**ALLEN & MAJOR
ASSOCIATES, INC.**

DRAINAGE REPORT

ADA ACCESSIBLE CURB CUT AND TRANSITION
NOT TO SCALE

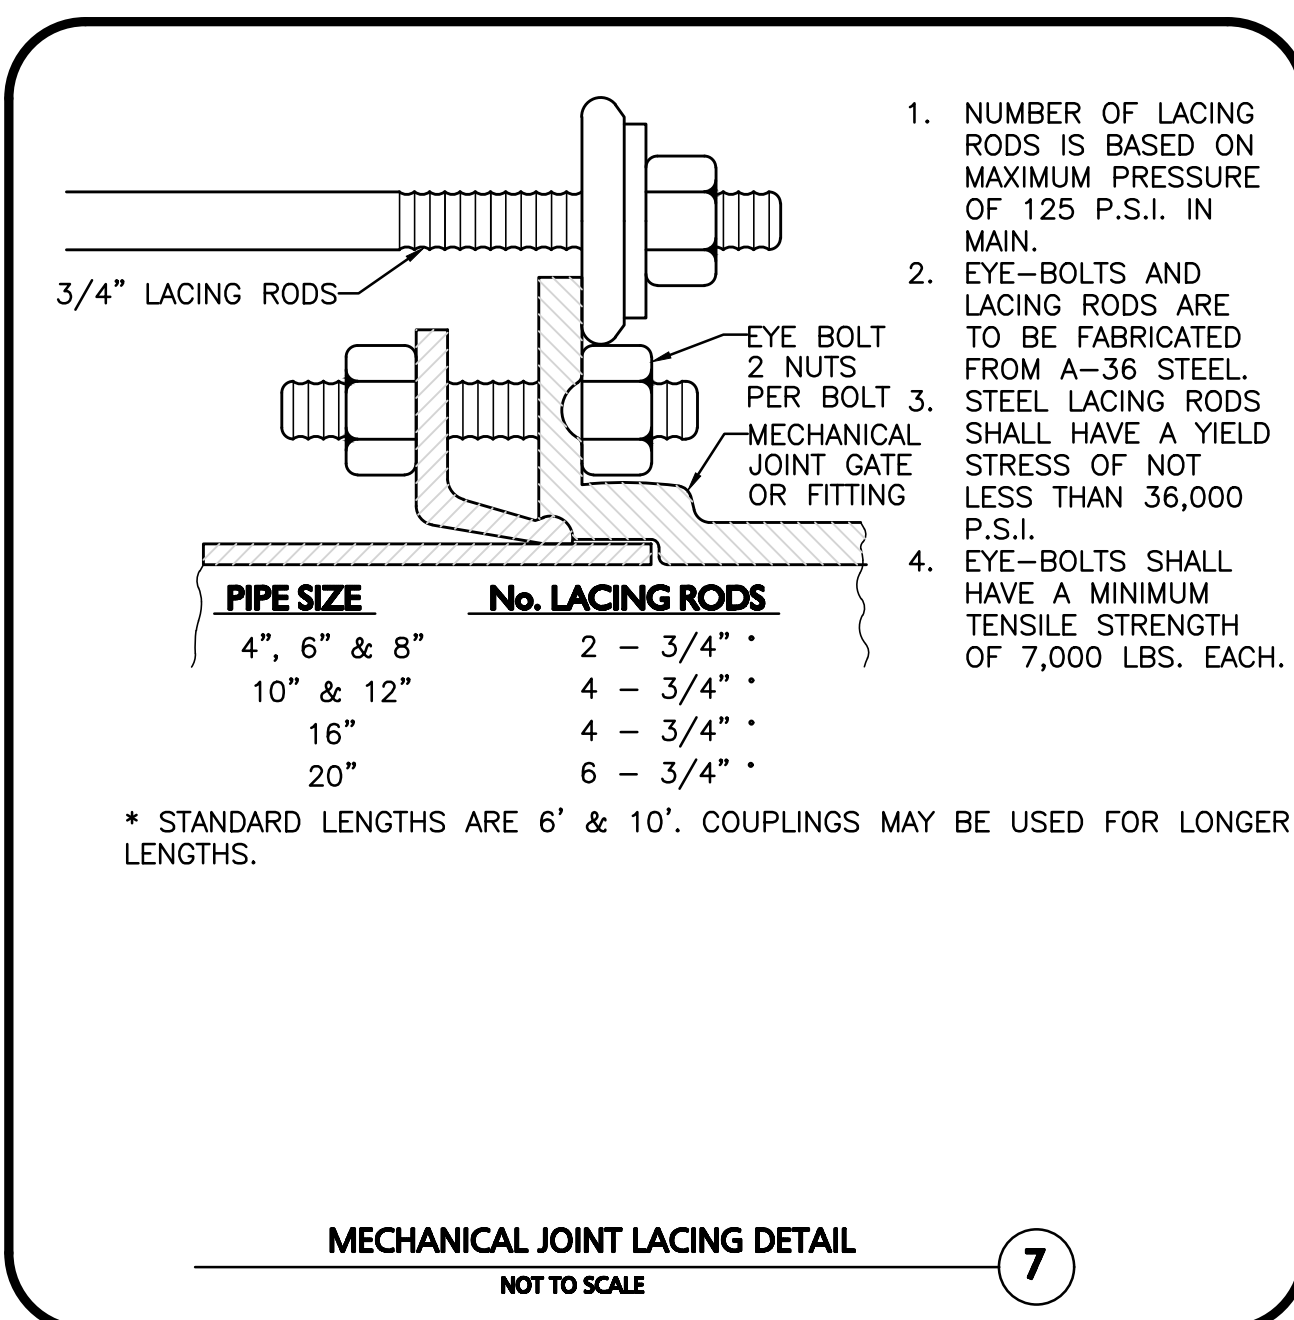
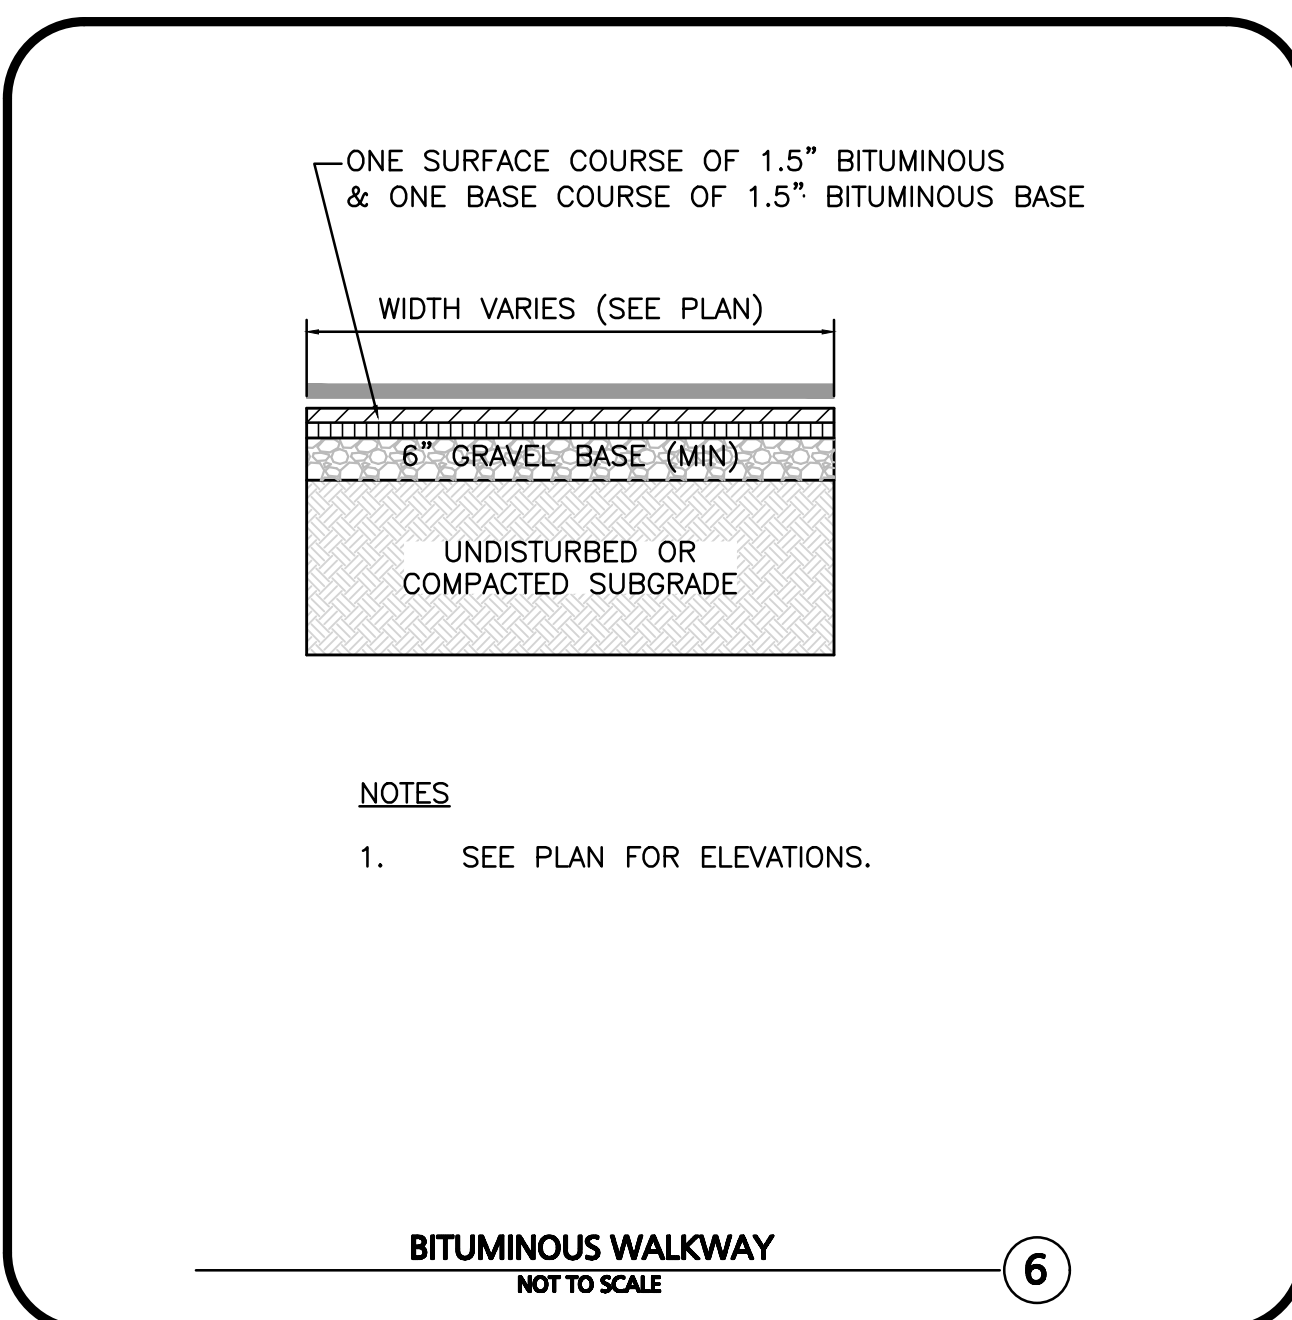
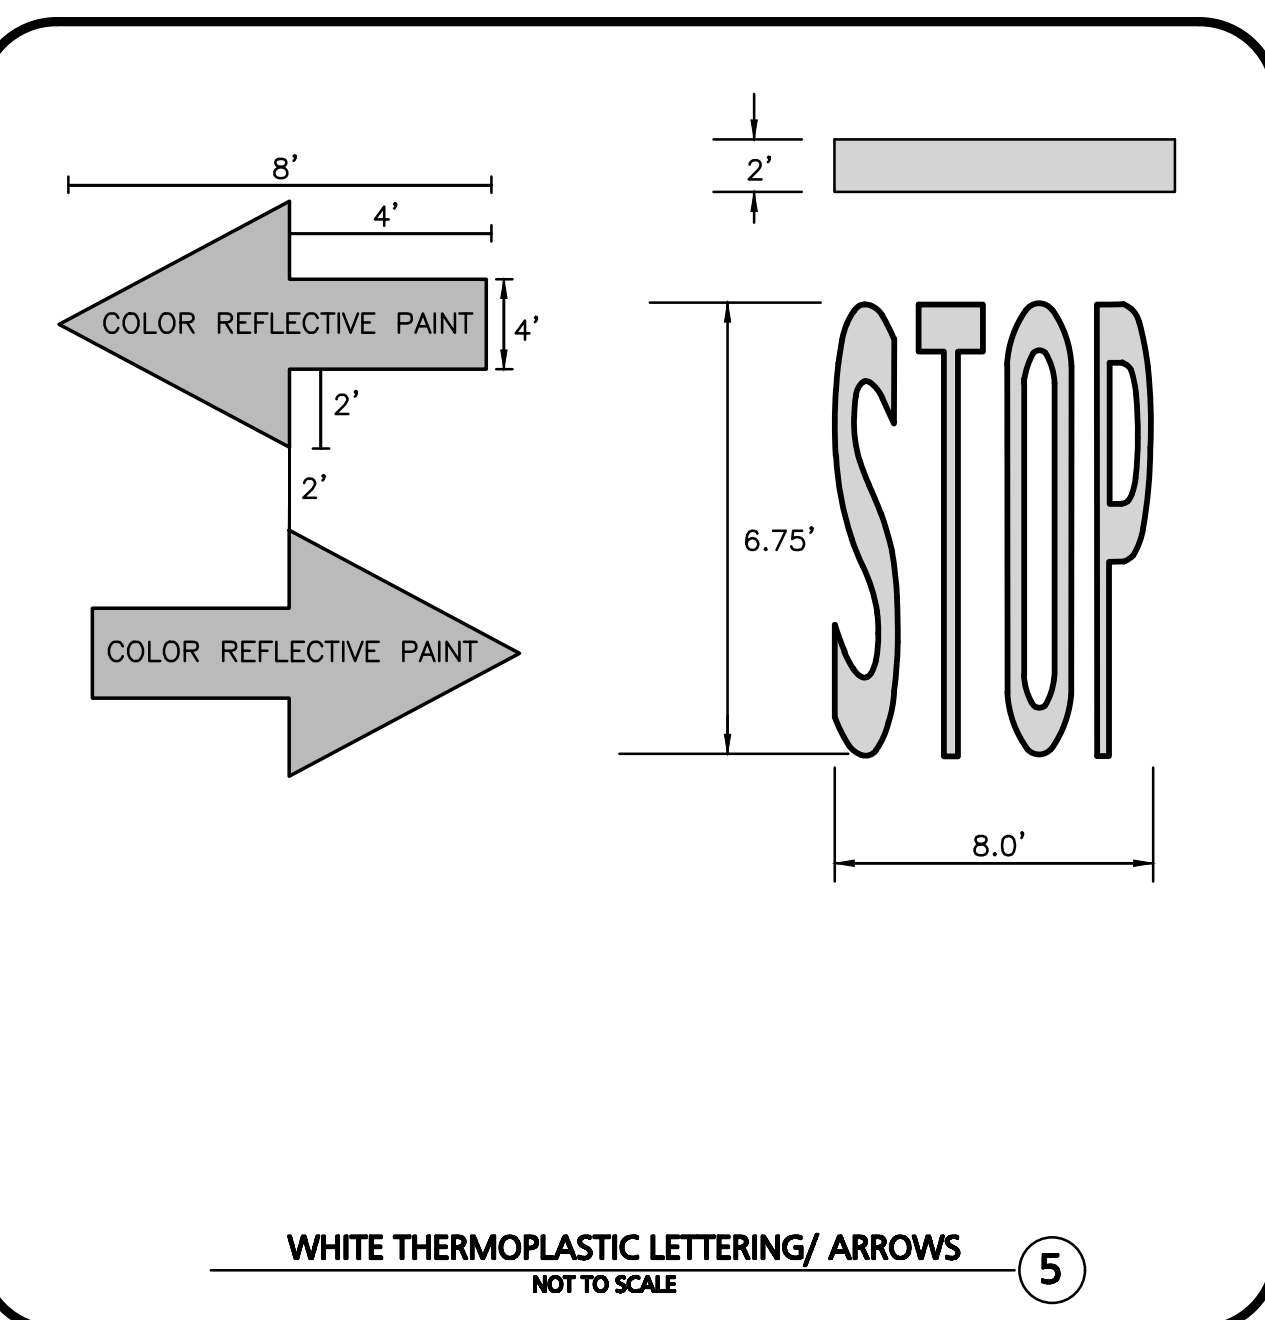
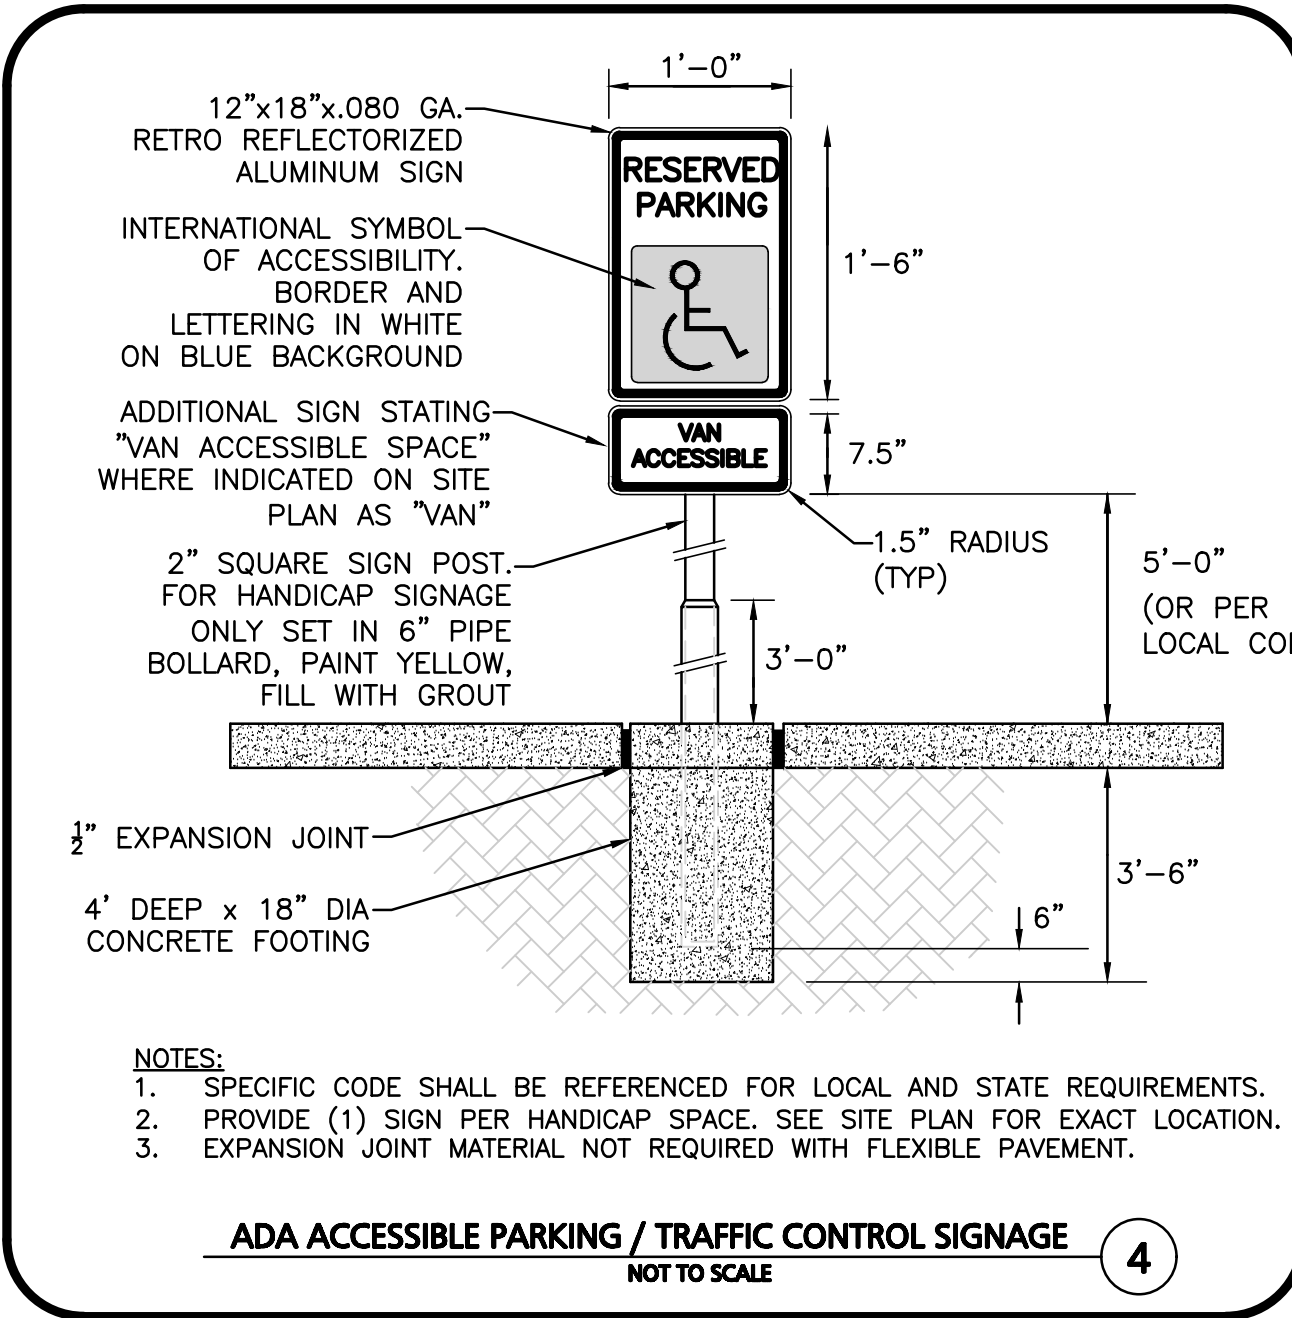
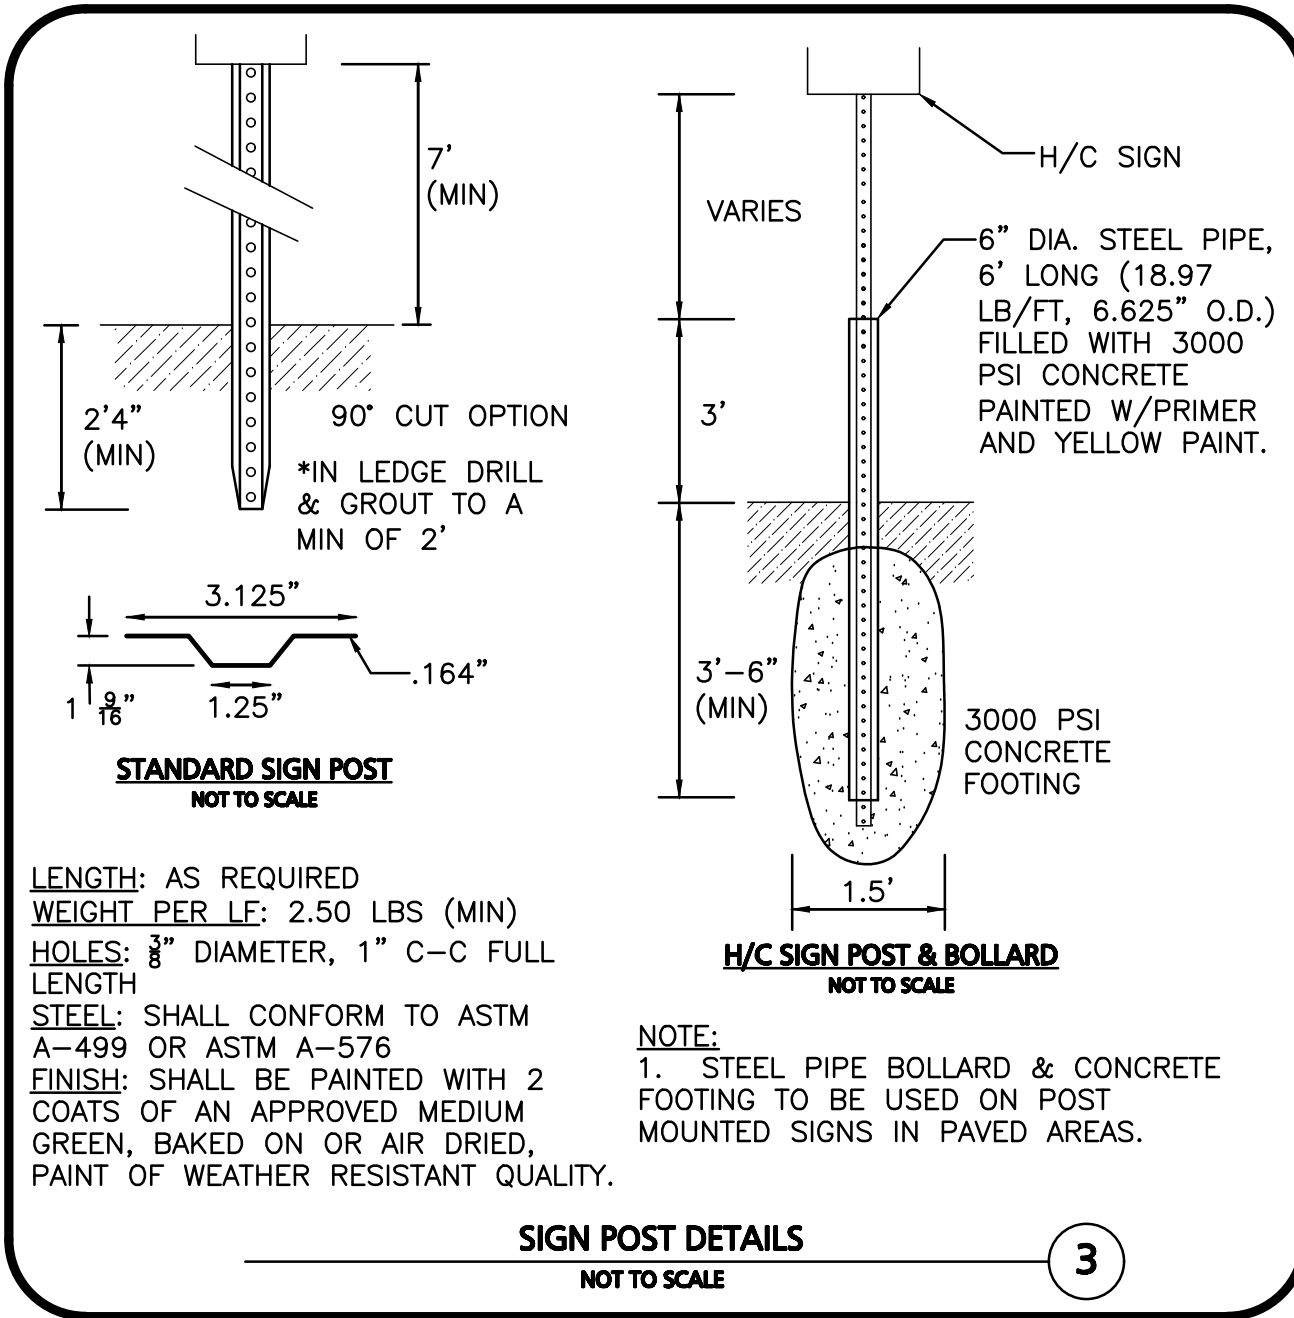
REV	DATE	DESCRIPTION
B	3/25/2024	REVISED PER TOWN COMMENTS
A	2/29/2024	REVISED PER TOWN COMMENTS
